SANITARY SEWER EXTENSION FOR

"RESTHAVEN CEMETERY"

12-29-03 AS-BUILT HOF N/CED

PLAN & PROFILE OF
SANITARY SEWER
RESTHAVEN CEMETERY, WICHITA, KANSAS
CED PROJ. NO.: 20020842

SHEET
3R
TOTAL 7

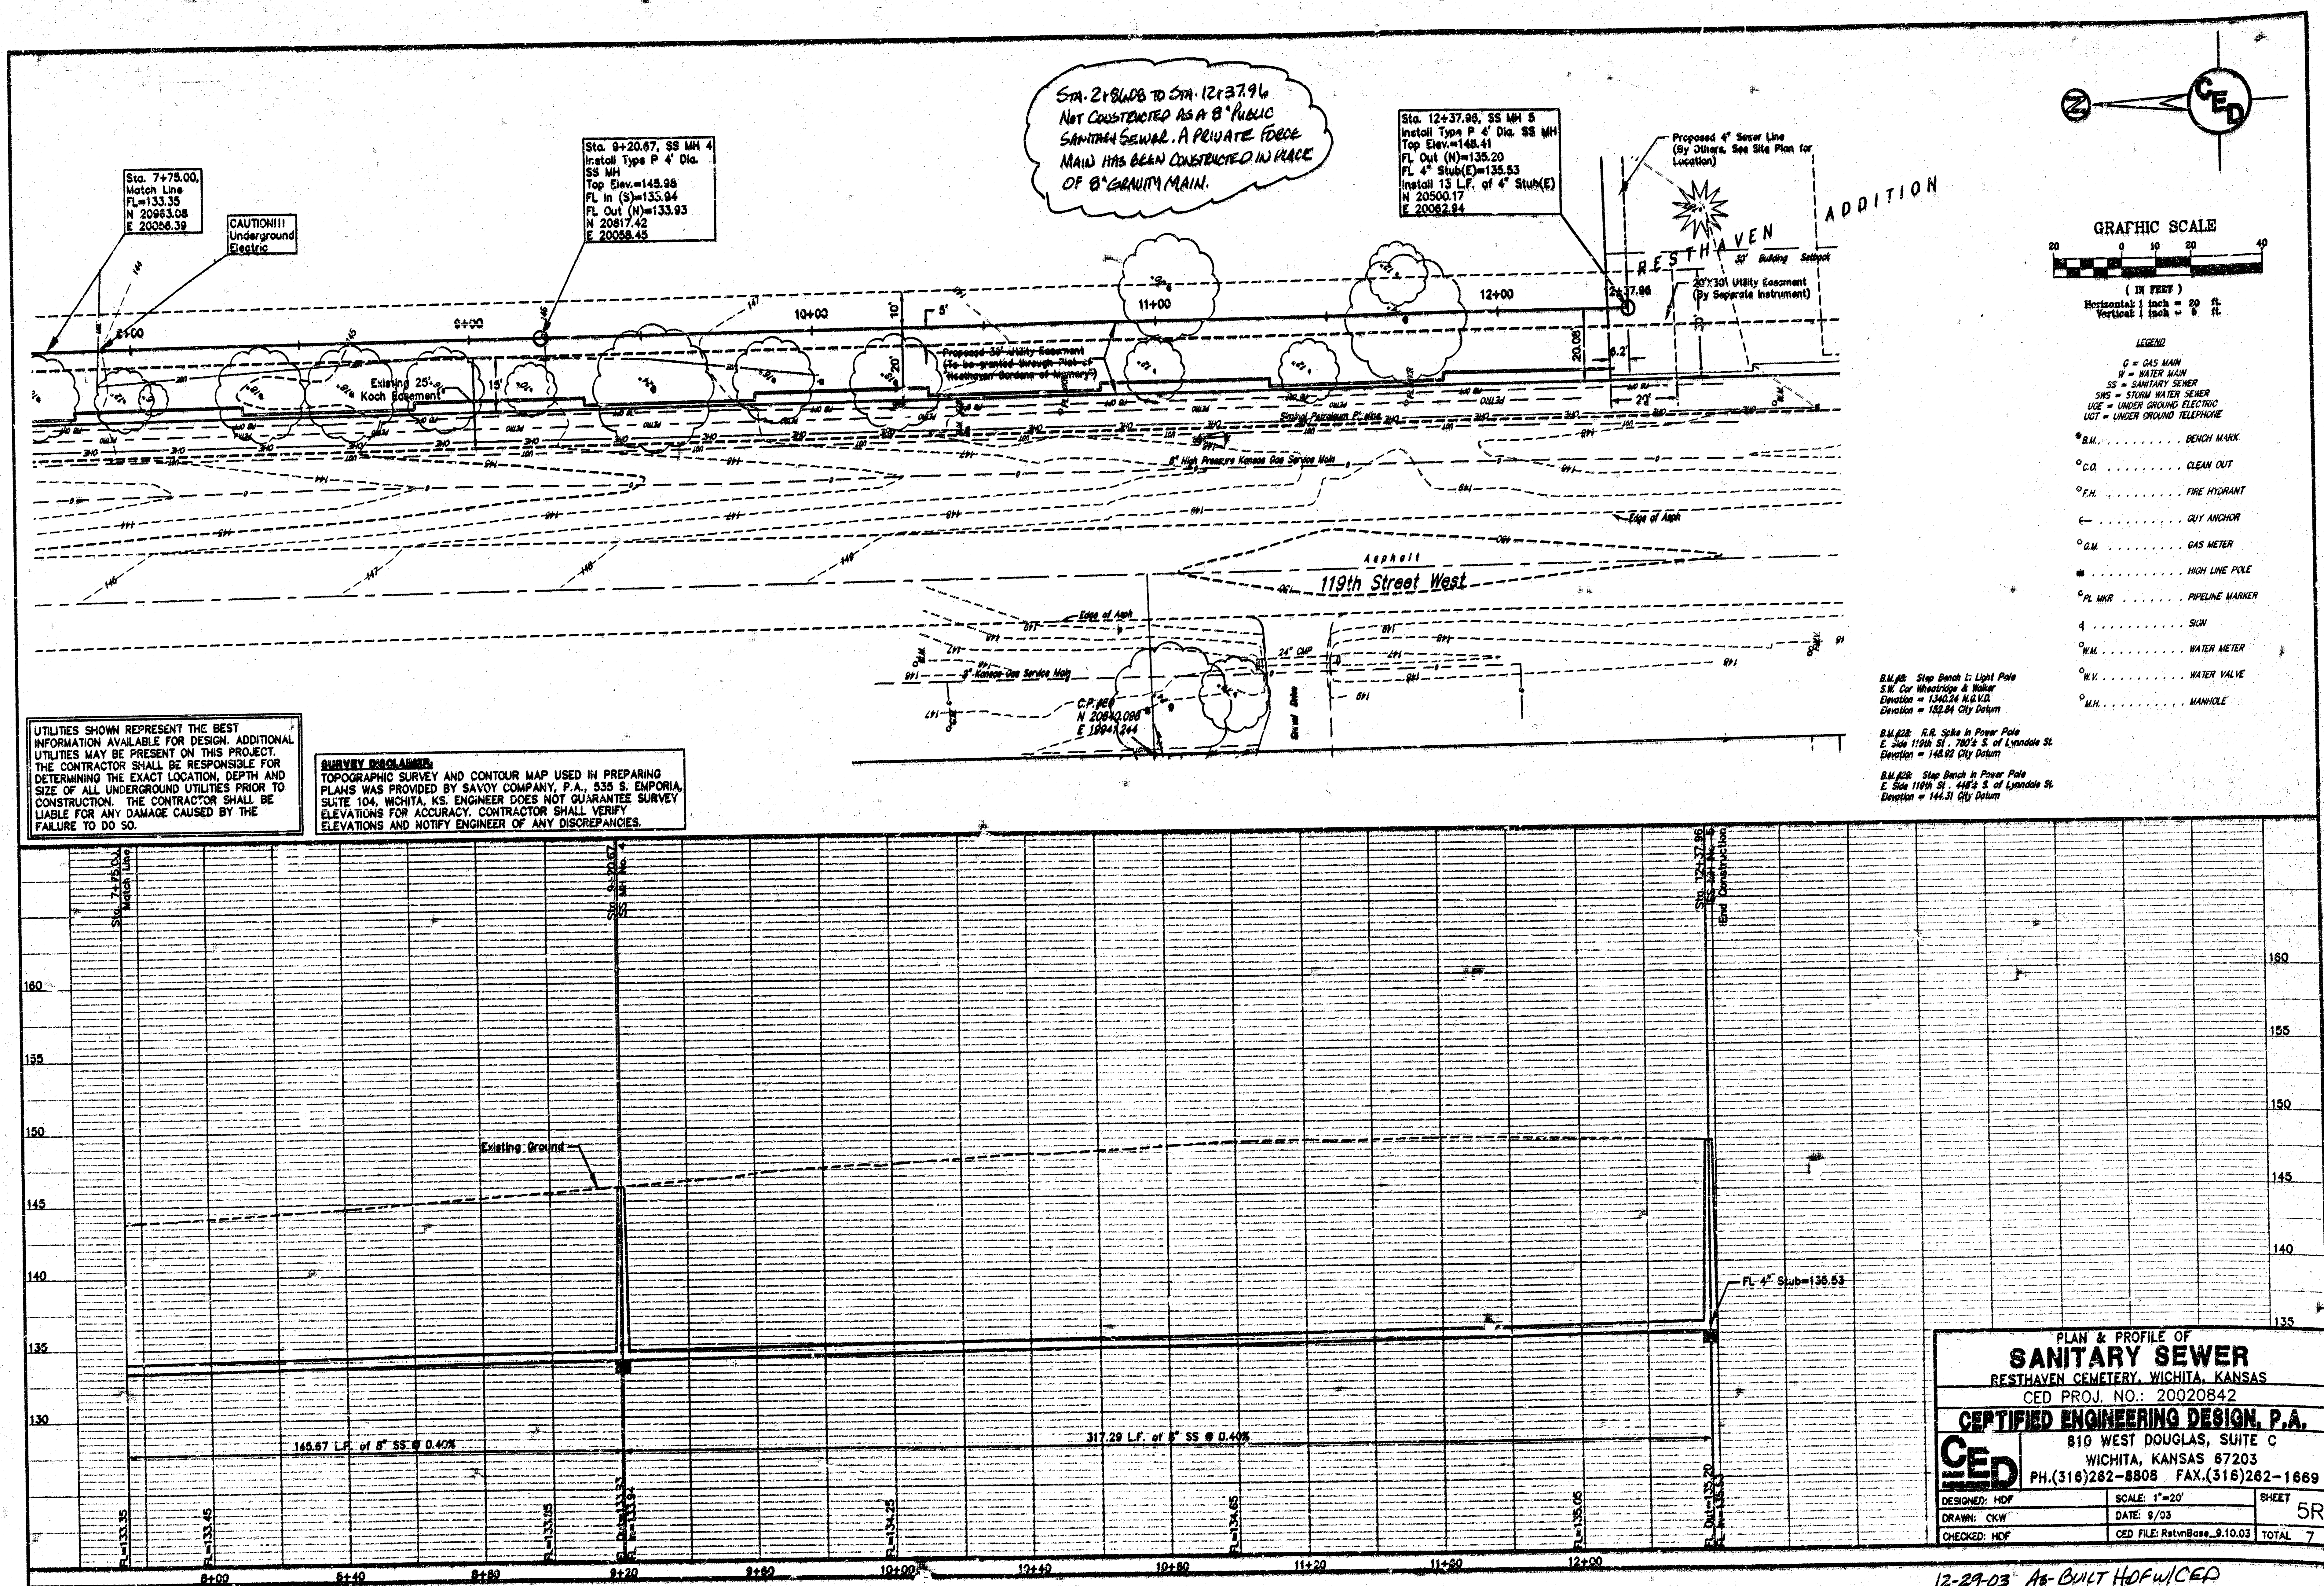
STA. 2+84.08 TO STA. 12+37.96
NOT CONSTRUCTED AS A 8" PUBLIC
SANITARY SEWER. A PRIVATE FORCE
MAIN HAS BEEN CONSTRUCTED IN PLACE
OF 8" GRAVITY MAIN.
